TECHNICAL BULLETIN

[Issue No.] GOT-A-0088

[Title] Changes in License Key Appearance for GT SoftGOT2000 and GT SoftGOT1000

[Relevant Models] GOT2000 Series, GOT1000 Series

1. Changes in license key appearance (GT27-SGTKEY-U, GT15-SGTKEY-U)

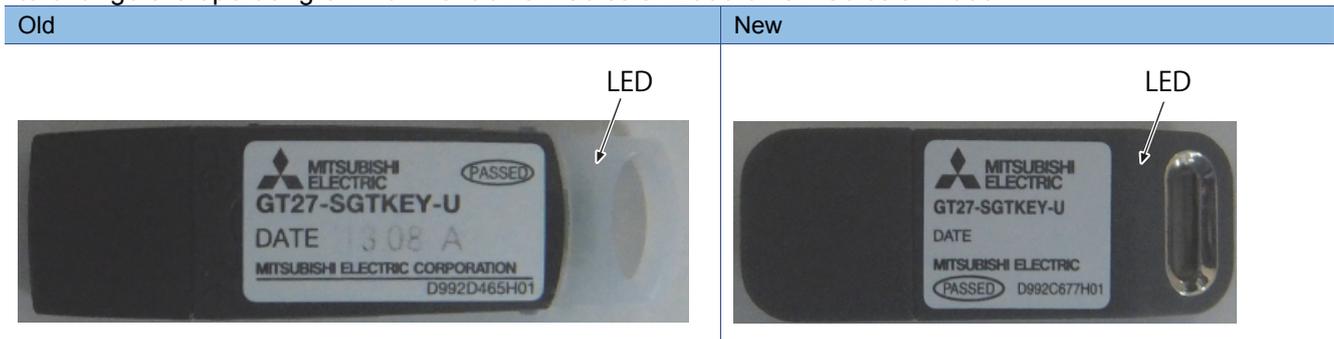
The appearance and rating plate of the USB license key (GT27-SGTKEY-U) for GT SoftGOT2000 and the USB license key (GT15-SGTKEY-U) for GT SoftGOT1000 will be changed.

The license key becomes shorter, and the color of the license key is changed from black to gray.

In addition, the LED color is changed from green to red and the LED location is changed.

No electric performance specifications are changed compared to the old license key, and you do not have to change the operating environment of GT SoftGOT2000 or GT SoftGOT1000.

2. Changes of the rating plate

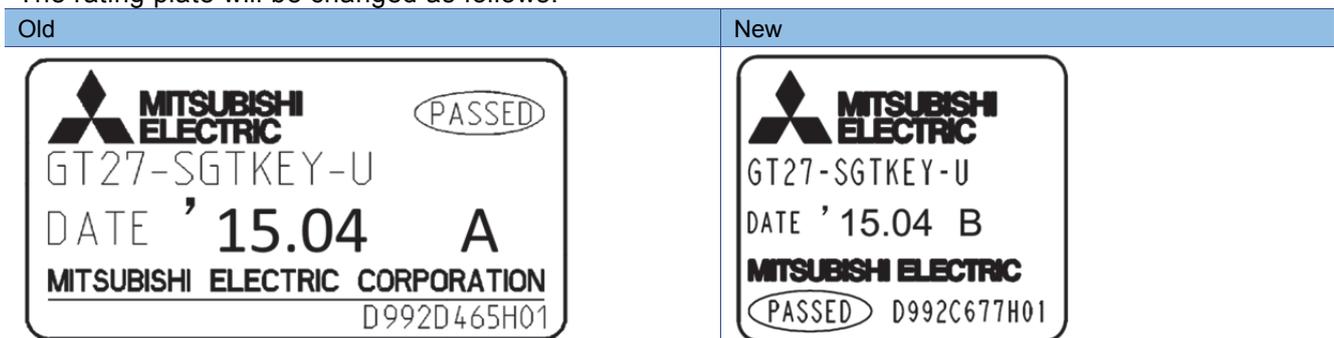
The rating plate will be changed as follows.

3. How to identify the new license key

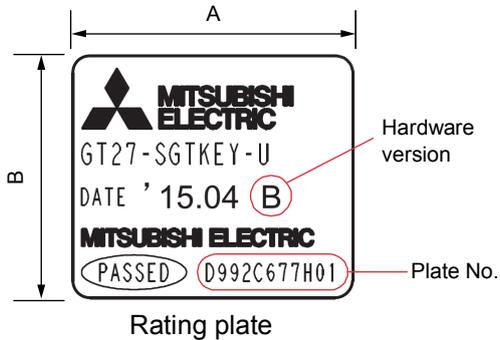
You can identify the new license key by checking the rating plate (plate number and hardware version) as shown below.

Item		Old	New
Dimensions (A × B [mm])		25.0×13.0	16.0×14.0
Plate No.	GT27-SGTKEY-U	D992D465H01	D992C677H01
	GT15-SGTKEY-U	D992D465H02	D992C677H02
Hardware version	GT27-SGTKEY-U	A	B
	GT15-SGTKEY-U	D	E
